SERVICE BULLETIN

Classification: EL01-001	Reference: NTB01-009	Date: February 9, 2001
-----------------------------	-------------------------	---------------------------

2001 MAXIMA ALARM SOUNDS AFTER 30 MINUTES AND/OR TRUNK LAMP INOPERATIVE

- APPLIED VEHICLES:** 2001 Maxima (A33)
APPLIED VINS: Vehicles built before: JN1CA31A*1T104331
 JN1CA31A*1T304531
 JN1CA31D*1T611224
 JN1CA31A*1T809711
APPLIED DATE: Vehicles built before September 22, 2000

Figure 7

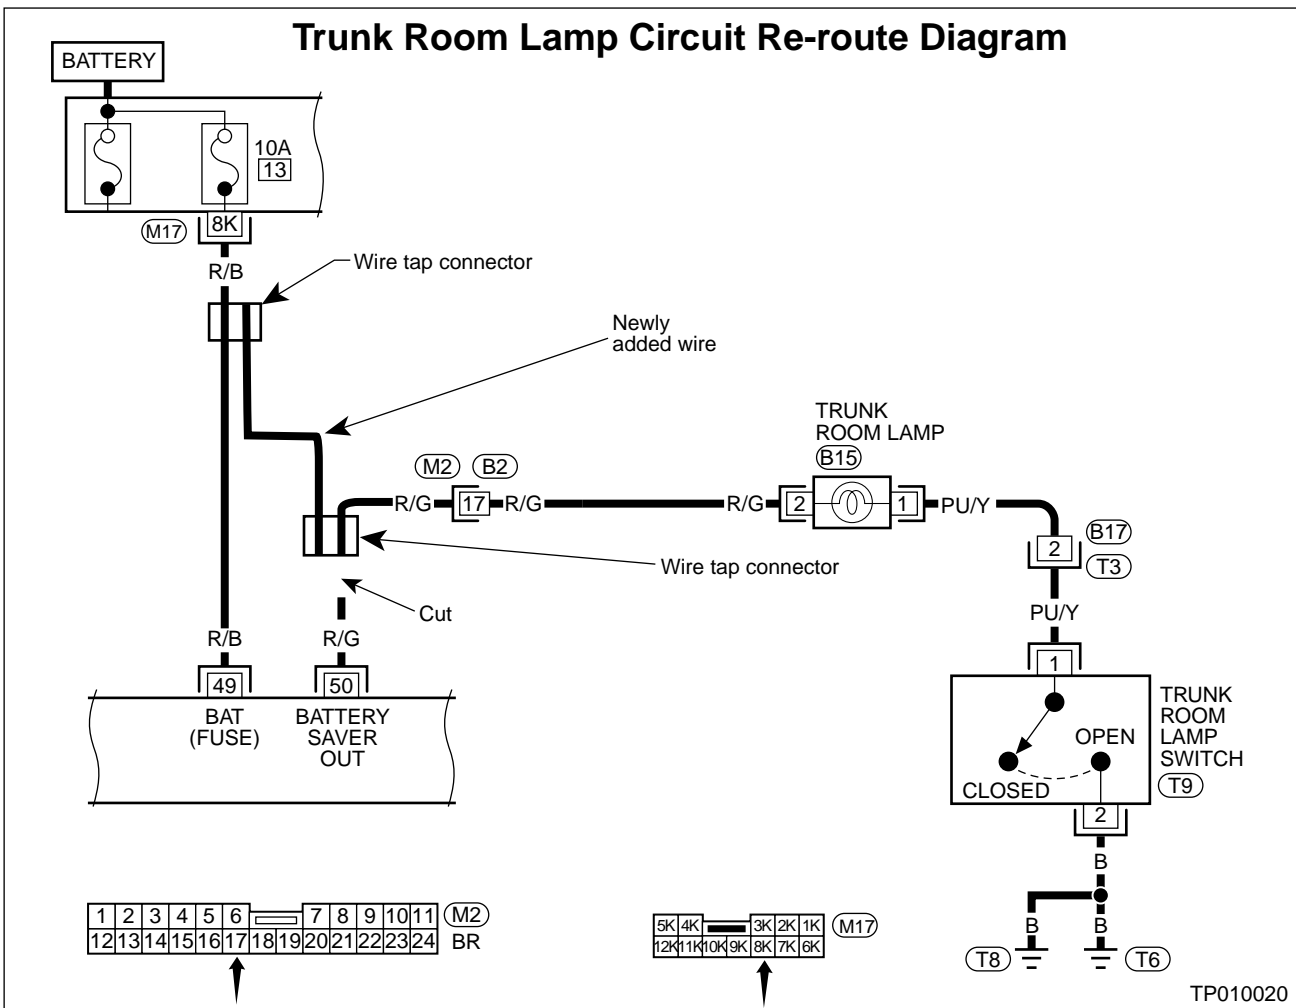
NOTE: See Figure 7 for an overview of this repair:

Figure 8

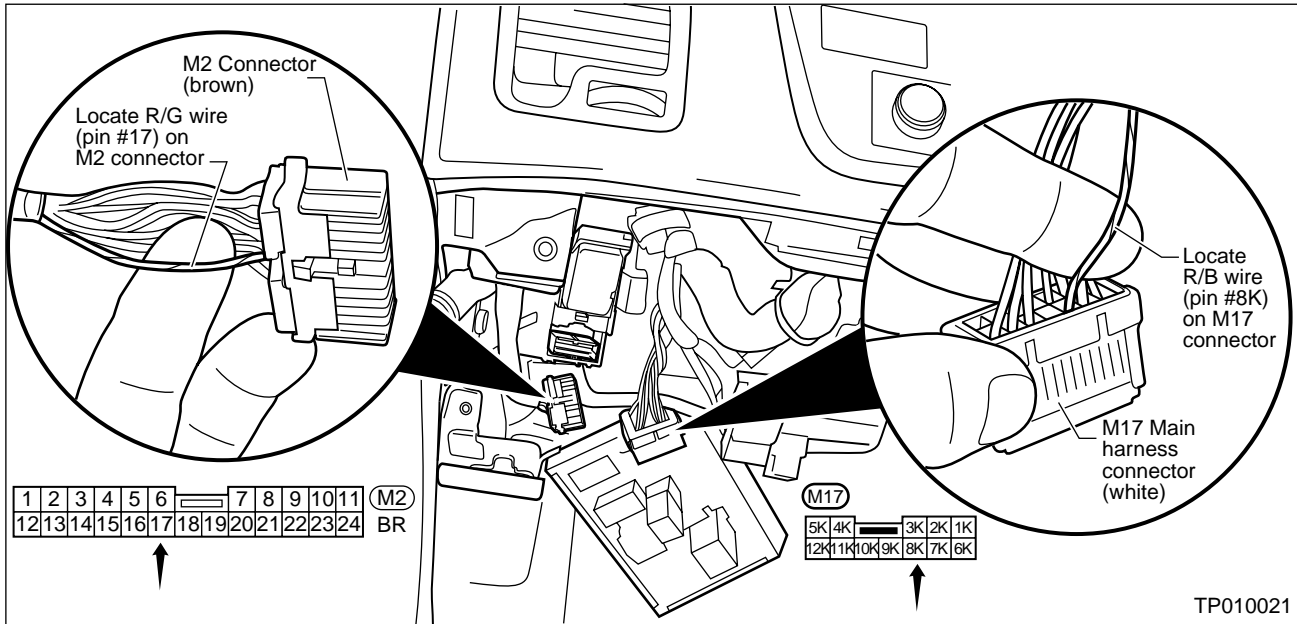
11. Locate the R/B wire (pin #8K) on the M17 main harness connector (white) which was disconnected in step 9 (see Figure 8).

12. Locate the R/G wire (pin #17) on the M2 connector (brown) which was disconnected in step 10 (see Figure 8).

Figure 9

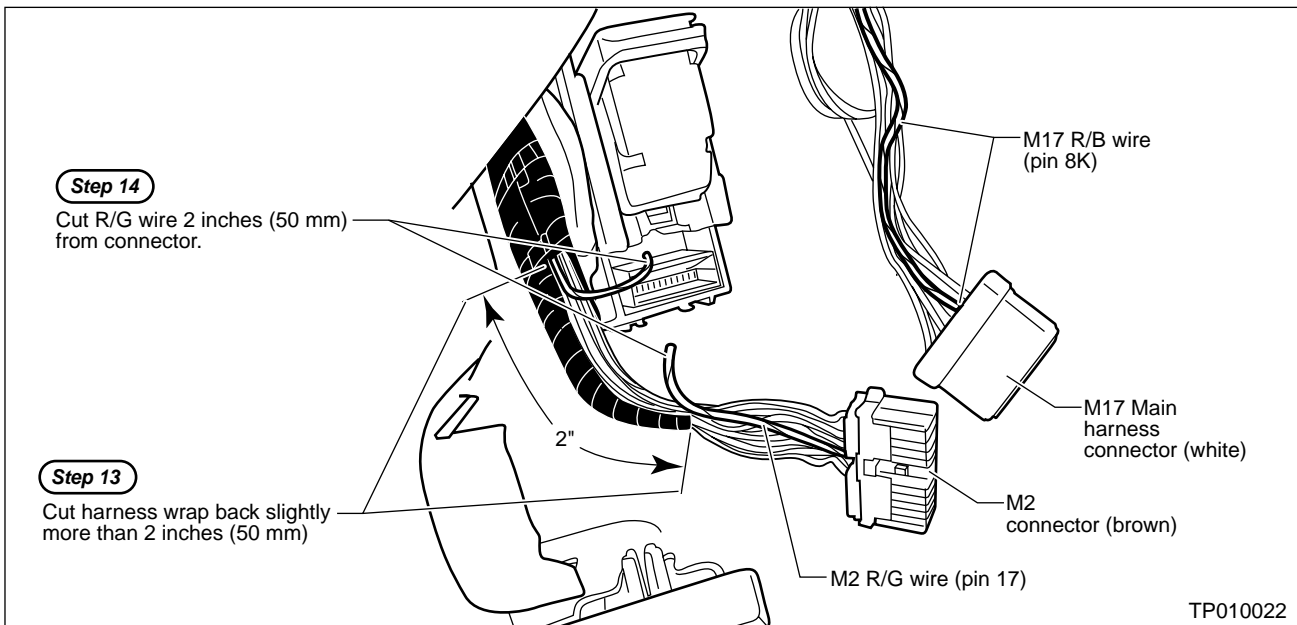
13. Cut the harness wrap surrounding the M2 connector wires back slightly more than 2 inches – 50 mm (see Figure 9).

14. Cut the R/G wire on the M2 connector 2 inches (50 mm) from the connector (see Figure 9).

Figure 10

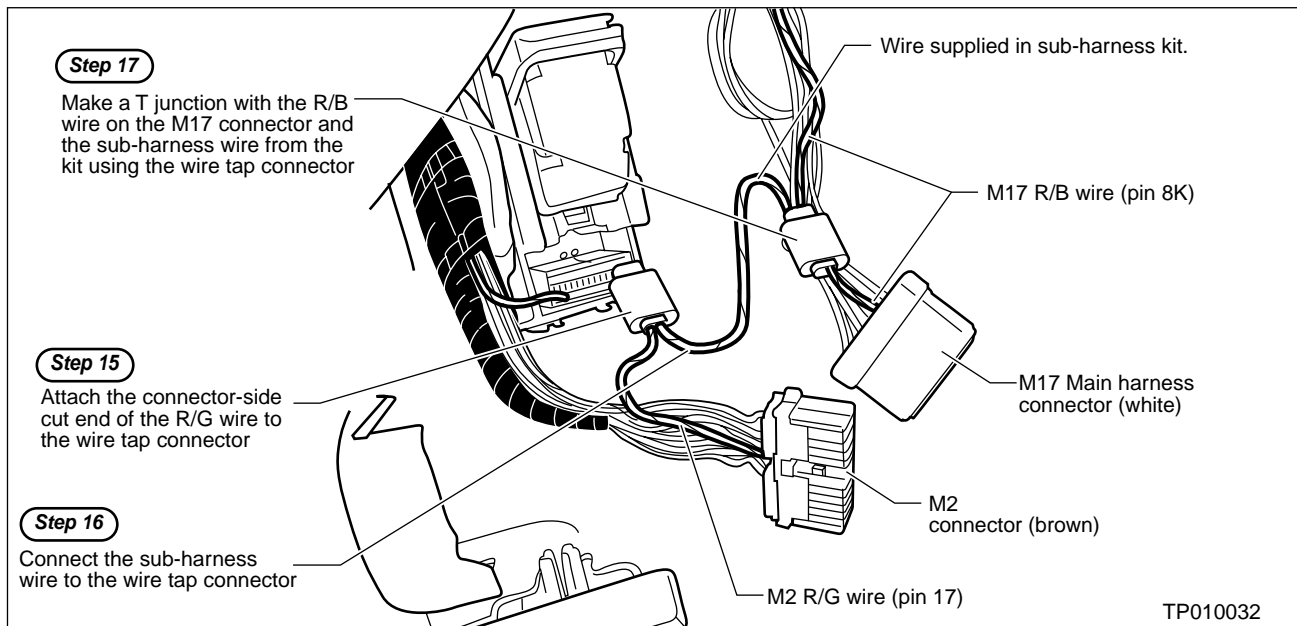
15. Attach the connector-side cut end of the R/G wire to one of the wire tap connectors provided in the sub-harness kit (see Figure 10).

16. Connect one end of the sub-harness wire (provided in the sub-harness kit) to the wire tap connector attached to the R/G wire in step 15 (see Figure 10).
17. Make a T junction with the R/B wire located on the M17 connector and the other end of the sub-harness wire using the other wire tap connector provided in the sub-harness kit (see Figure 10).
18. Route the new sub-harness wire away from sharp edges or places it may be chafed.
19. Re-wrap the exposed wires of the M2 connector harness (including the harness-end cut R/G wire) with electrical tape.
20. Re-install all parts removed in reverse order.
21. Perform the following **Confirmation Test** to verify the incident is resolved.
